SUBJECT: Analysis of the Apollo Entry  
Monitor System's  $\Delta V$  Counter  
Case 320

DATE: April 16, 1969

FROM: D. O. Baechler  
R. Lindner, BTL

MEMORANDUM FOR FILE

FIGURE 3 - LOGIC RACE

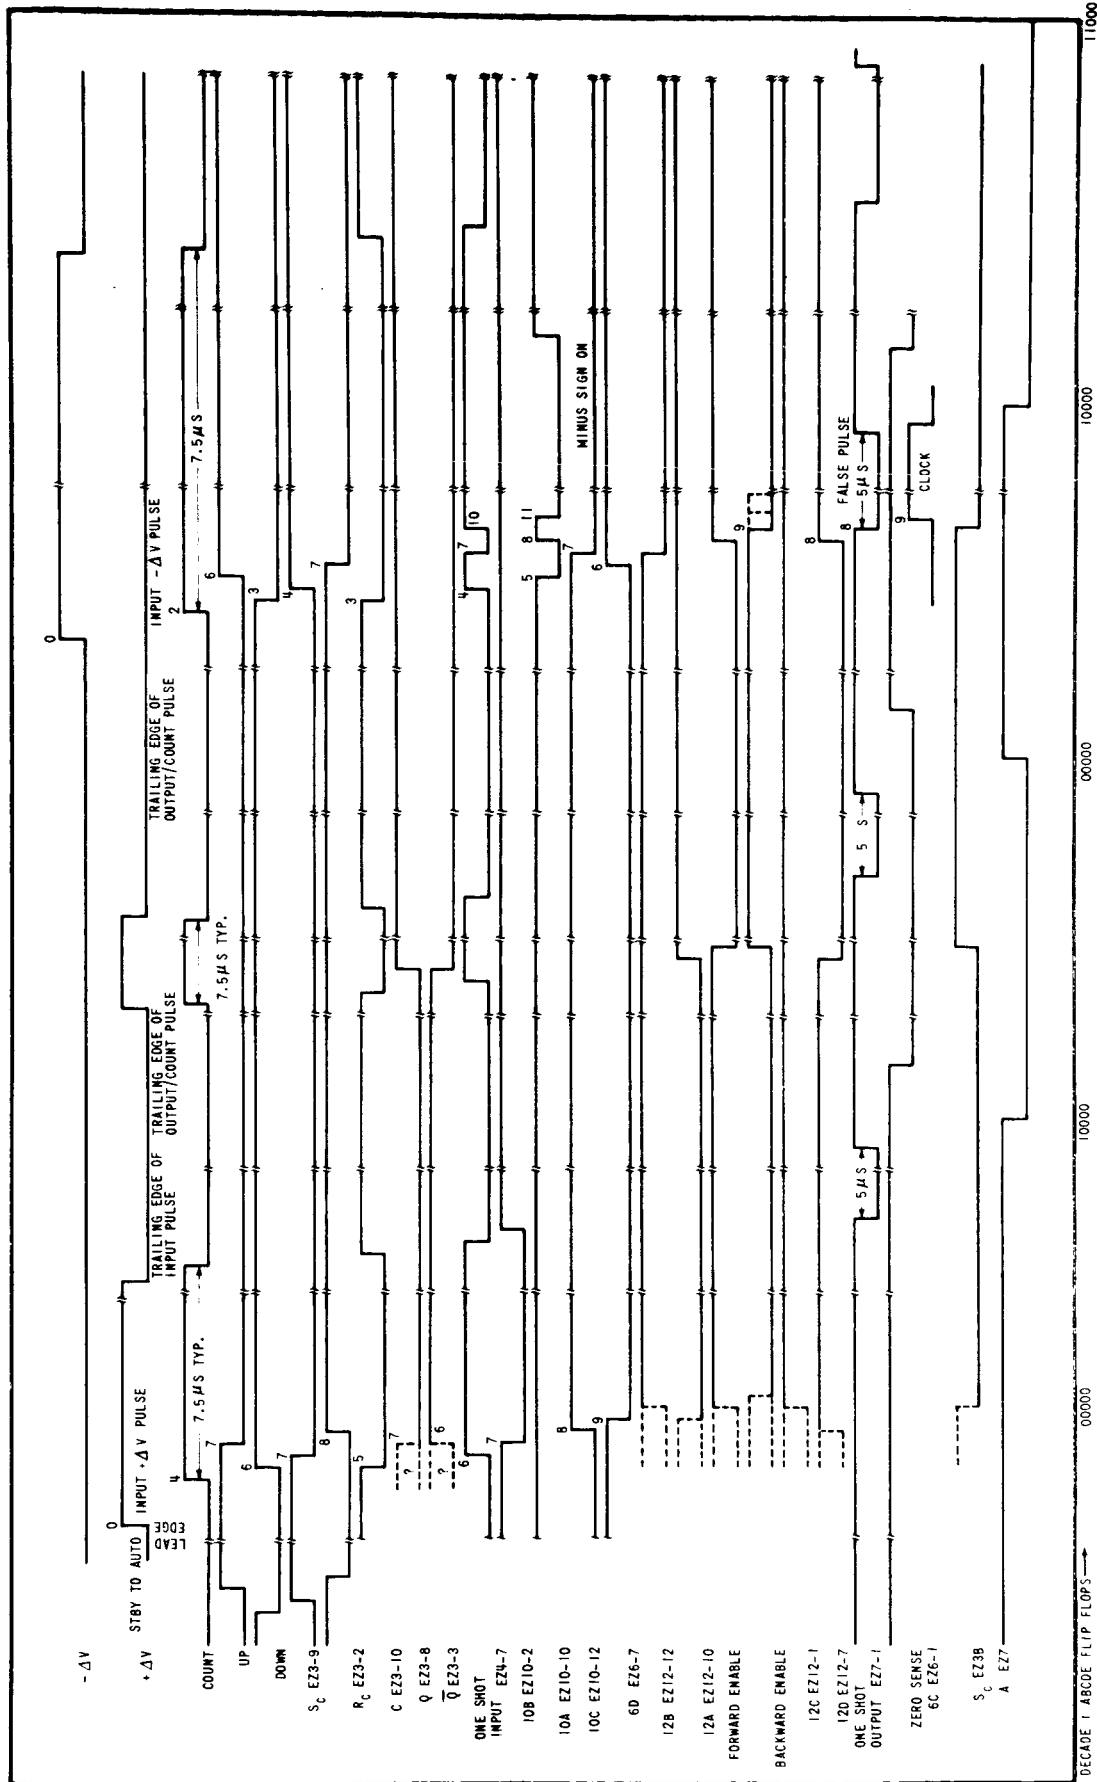
A situation that could cause a false jump has been described by R. A. Harris of Autonetics and is shown in the timing diagram of Figure 3. Starting from an all zero condition in the display, two  $+\Delta V$  pulses are followed by a  $-\Delta V$  pulse resulting in the backward enable signal being still high when a clock pulse arrives at the backward transfer gate. Since the output of the backward transfer gate is interpreted as a count pulse in the next decade, subsequent decades may count to nine.

This situation has been examined in greater detail by using maximum propagation delay times. Starting with  $t=0$  at the leading edge of the  $-\Delta V$  pulse and using the same logic states as in Figure 3 up to that time, the pulse times are recorded in Figure 4 for each point in the logic. In particular, it can be seen in Figure 4 that because of unequal gate delays from  $-\Delta V$  to the UP and DOWN points, a 125ns negative going pulse is found at the output of gate 2C. Then since the COUNT pulse has arrived at gate 4A before this, a short pulse preceding a slightly shortened 7.5 $\mu$ s pulse is caused at the input to the one shot. This short pulse falls to zero at 231ns, triggering a one shot pulse at 266ns. The pulse from the one shot is inverted by gate 1A to become a positive clock pulse for both the counter flip-flops in decade 1 and the transfer gates to decade 2. This is an unwanted or false pulse. However, since the clock pulse must charge a 70pF capacitor at each flip-flop, the switching delay of gate 1A can be 90ns, giving a time of 356ns before the clock pulse can reach the backward transfer gate 12B.

FIGURE 6 - PROPOSED LOGIC FOR COUNT INHIBIT

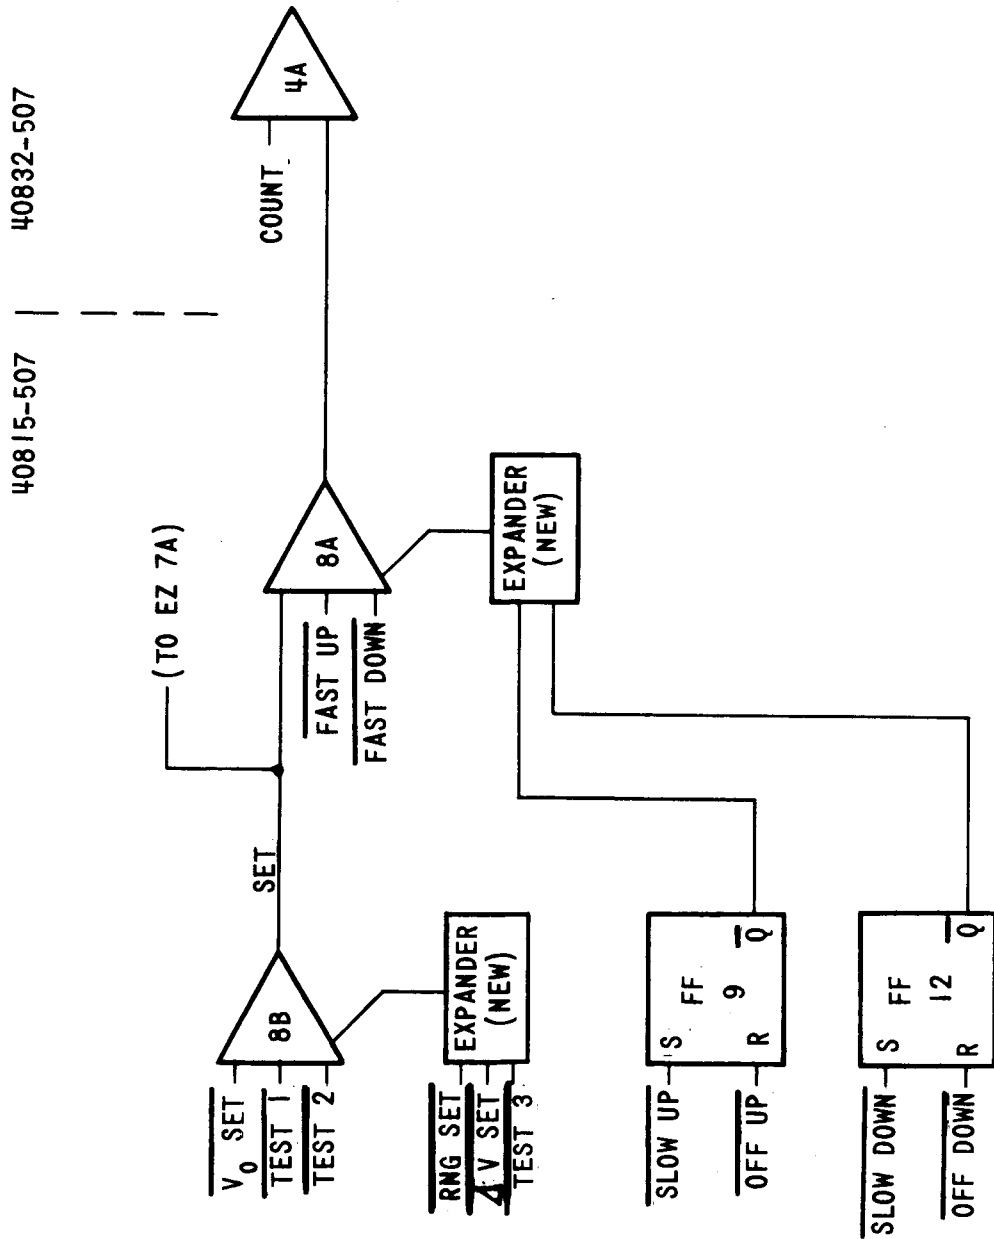
An alternate solution is to remove gate 2C, thereby eliminating the false pulse by eliminating the race. Gate 2C inhibits the count gate 4A when neither the UP line nor the DOWN line is high, so if it is removed the inhibit input to gate 4A must be provided in some other way.

The only time gate 2C is supposed to have a zero output is when the function switch is set to either  $V_0$  SET, RTG SET,  $\Delta V$  SET, TEST 1, TEST 2, or TEST 3 and the slew switch is not in the FAST or SLOW UP nor the FAST or SLOW DOWN position.

One method of accomplishing this is shown in Figure 6. Two expander gates (one package) have been added. The expander on EZ8B frees gates EZ8A and EZ7C. Then EZ8A is used with an expander to yield the function

Since this inhibiting signal is a function only of switch positions, it is not subject to faults caused by changes in  $+\Delta V$  and  $-\Delta V$  pulses. There are, of course, other similar methods that could be used. The particular method should be chosen by someone intimately familiar with both the logic design and operation of the EMS.

$$EZ8A = \overline{SET} + FAST\ UP + FAST\ DOWN + SLOW\ UP + SLOW\ DOWN$$

$$SET = V_0\ SET + TEST1 + TEST2 + RNG\ SET + \Delta V\ SET + TEST3$$

Gates EZ7C and EZ2C are not used.

FIGURE 7 - USING VHF RANGING LOGIC

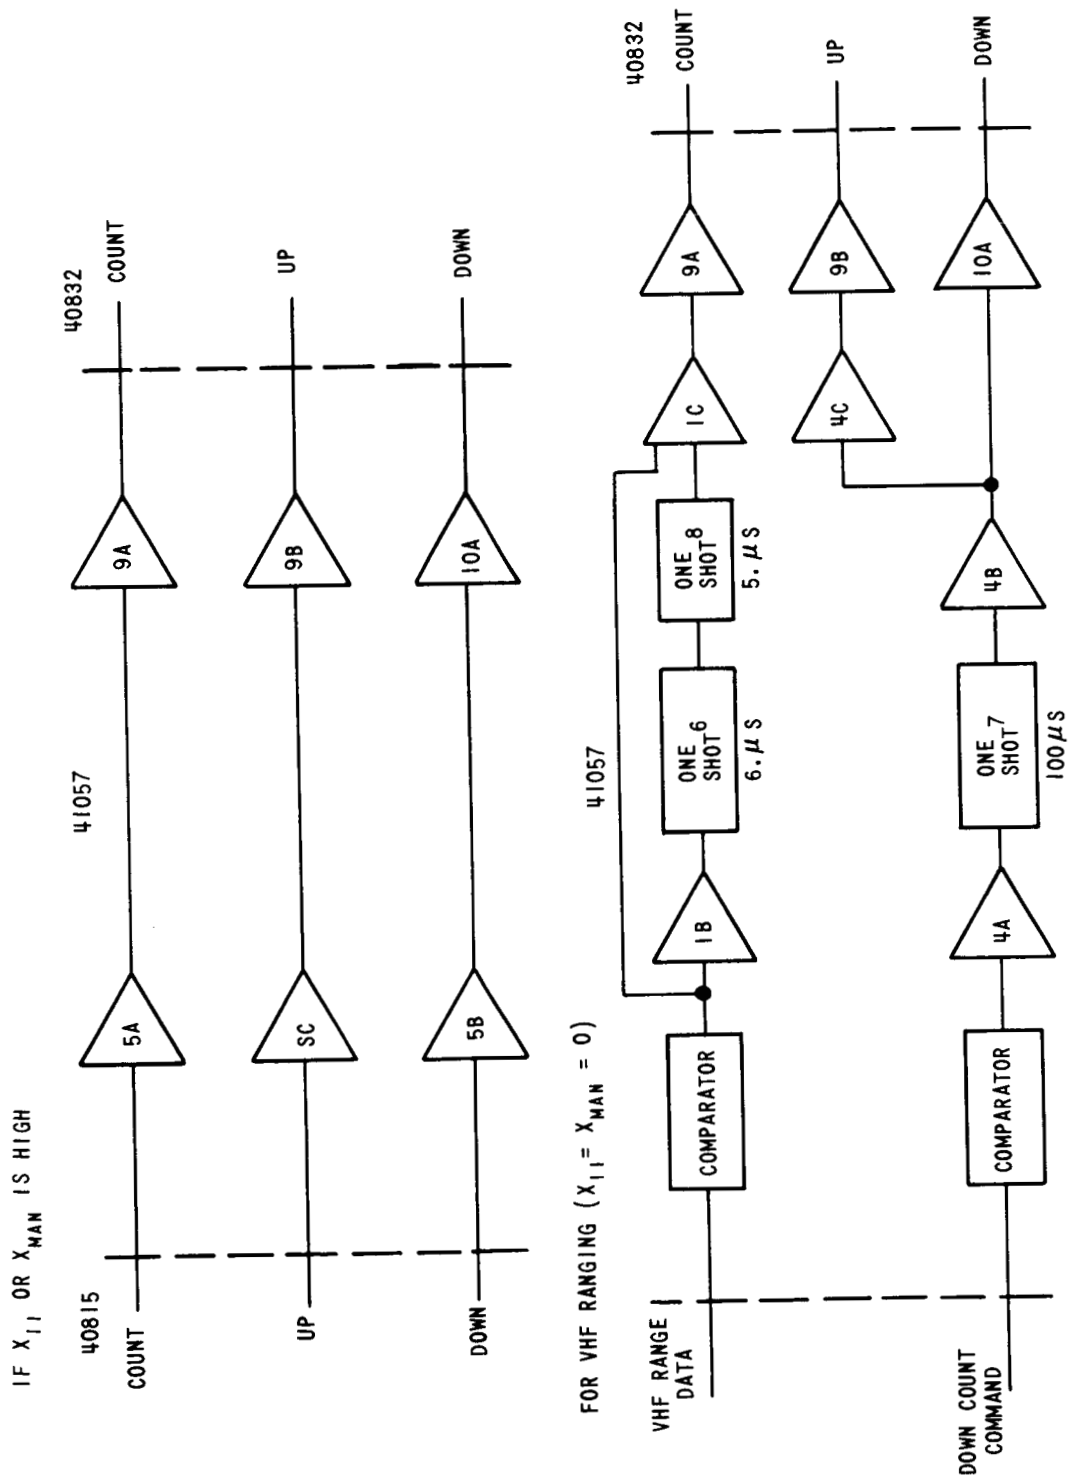
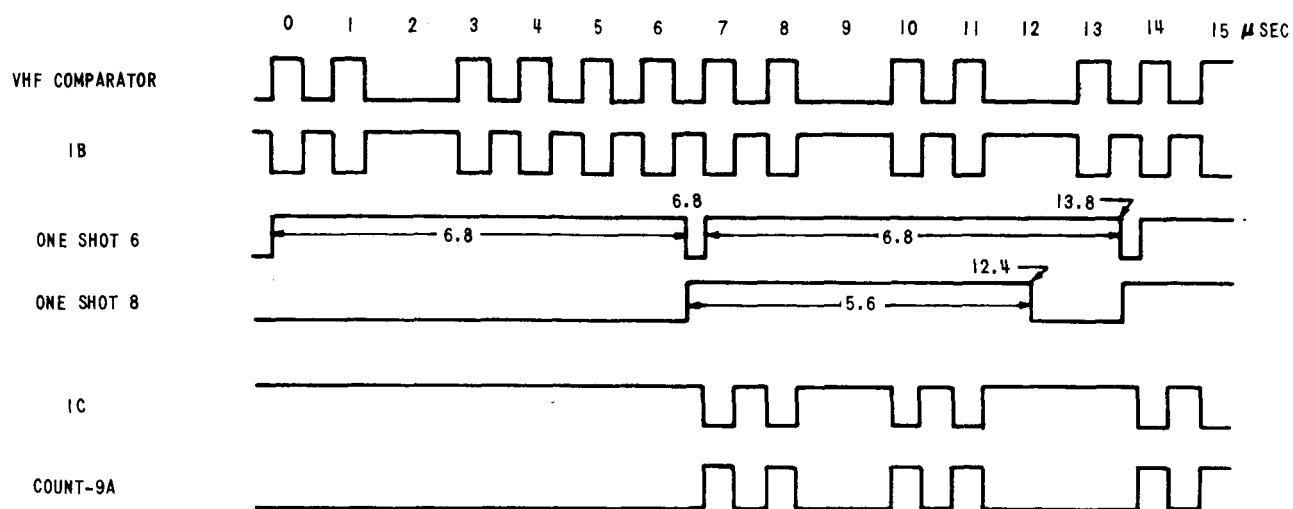
For CSM 106 VHF ranging can also use the same counting logic. As shown in Figure 7, if either  $X_{11}$  or  $X_{MAN}$  is high, the VHF logic is simply a pair of gates inserted at the COUNT, UP and DOWN points of Figure 2. The false pulse will still occur and the jump to -99.2 or -100.(B) still should not (but might) occur. In fact, due to the slight difference in delay through gates 5A and 9A of Figure 7, compared to that of gates 5B and 10A, the margin against false backward transfer is increased from 98ns to 122ns.

At the bottom of Figure 7, the VHF logic is shown for the case when VHF ranging is being done. Figure 8 shows the appropriate pulse trains. The VHF data was assumed to be amplitude modulated but frequency modulation could as well be assumed. The down count command would forward enable the counter for almost 100 $\mu$ s. Since the UP pulse goes low before the DOWN pulse goes high, gate 2C of 40832 does not go low. Also, the one shot 6 delays any COUNT pulse for 6.8 $\mu$ s. Either fact is sufficient to prevent a false clock pulse. In addition, flip-flop 3 now clocks on the present down count command, assuming the command came at about the same time as the VHF data.

FIGURE 9 - SIGNETICS NAND GATE AND DRIVER

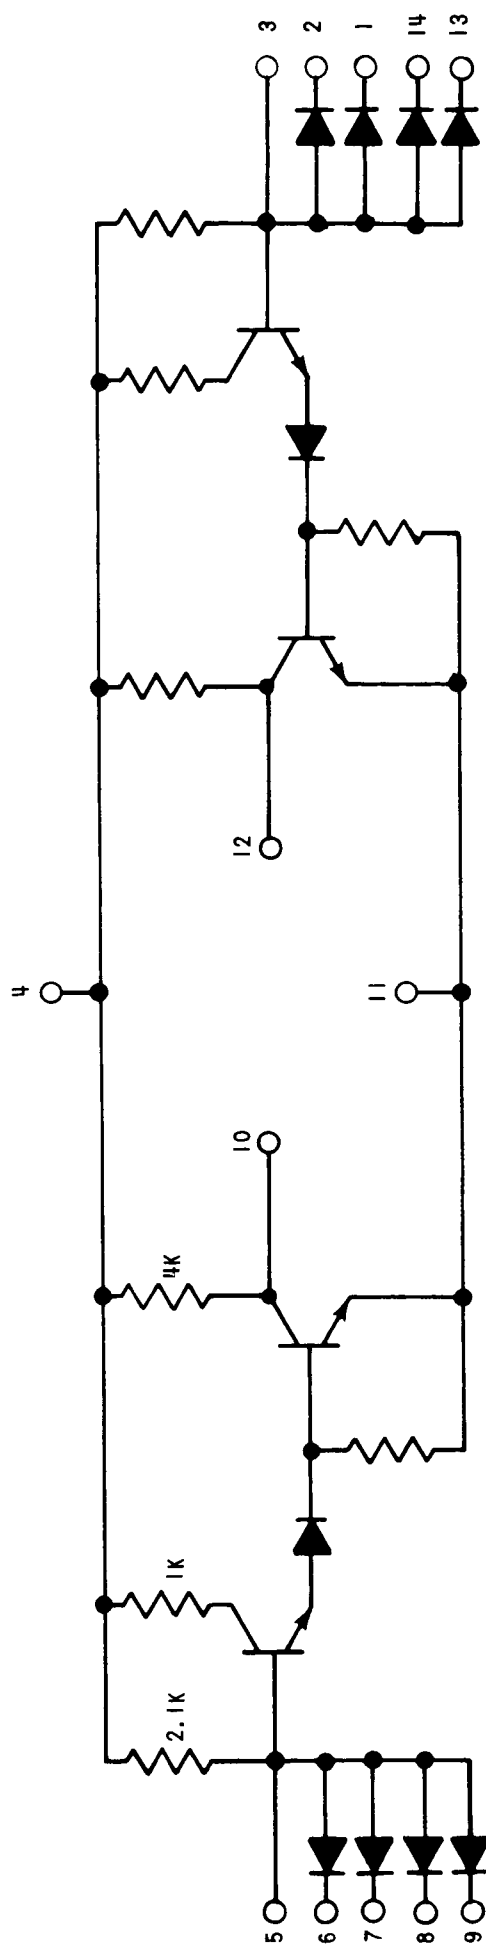
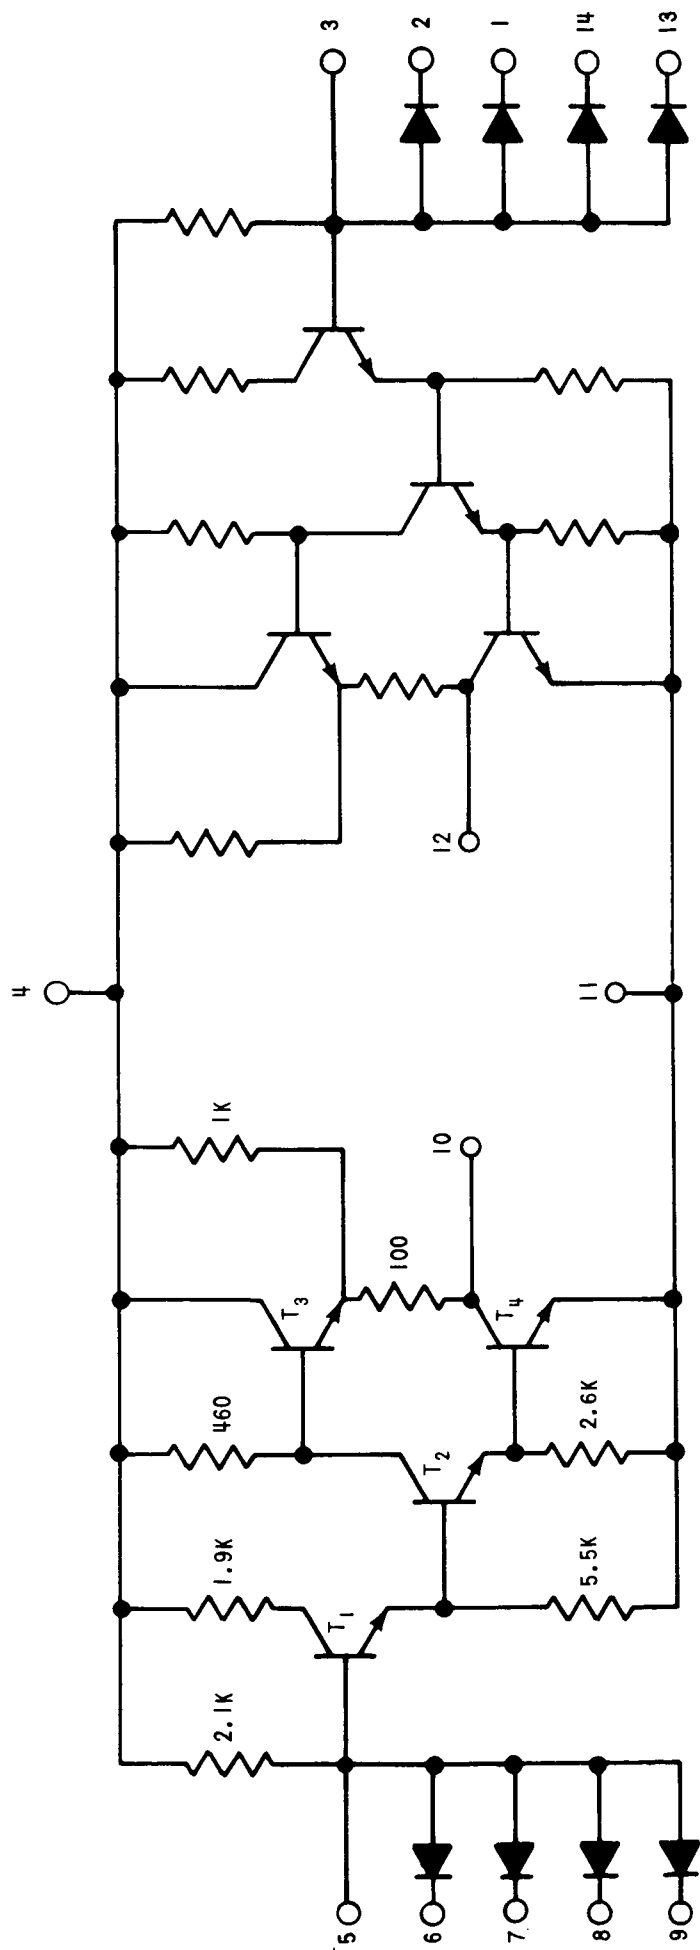
A commonly used gate in the EMS is the SE156J driver gate. This gate has an active pull-up due to transistor  $T_3$  in Figure 9. An active pull-up is necessary when driving lines with a large capacitive load. However, the active pull up also makes the gate a potential noise generator due to internal timing differences. Thus, when using the gate it is recommended practice to have a by-pass capacitor from  $V_{CC}$  to ground, connected close to the package. Also, when there is no capacitive load there is no need for the active pull-up driver and it should not be used.

In the EMS, the SE156J (477-0163-001) dual driver package is used 70 times with a total of 138 drivers connected. Six drivers (EZ1A of 40831) are certainly used properly as they must drive five clock inputs. Twenty-five others are used with high fan-out but not high capacitance. This could have been done with the SE111J which is a high fan-out gate without an active pull-up. Another 24 drivers were used only for their fan-in capability. Here the SE116J would have been the better choice. Both the SE111J and the SE116J have the same pinning as the SE156J. Finally, 32 drivers are used neither for fan-in nor fan-out but simply because they are available. The remaining 51 drivers are used for test positions or decoded outputs for which use an active pull-up driver is probably unnecessary but is considered as unknown. The complete list of packages and their loading is shown in Table 1.

Due to practical problems of package layout and device qualification it would seem advisable to recommend the replacement of only 24 of the SE156J packages. These packages are the ones in which neither driver is used for high fan-out and are indicated in Table 1. The replacement is the SE116J which as mentioned has the same pin designations and thus is a simple one-for-one replacement.
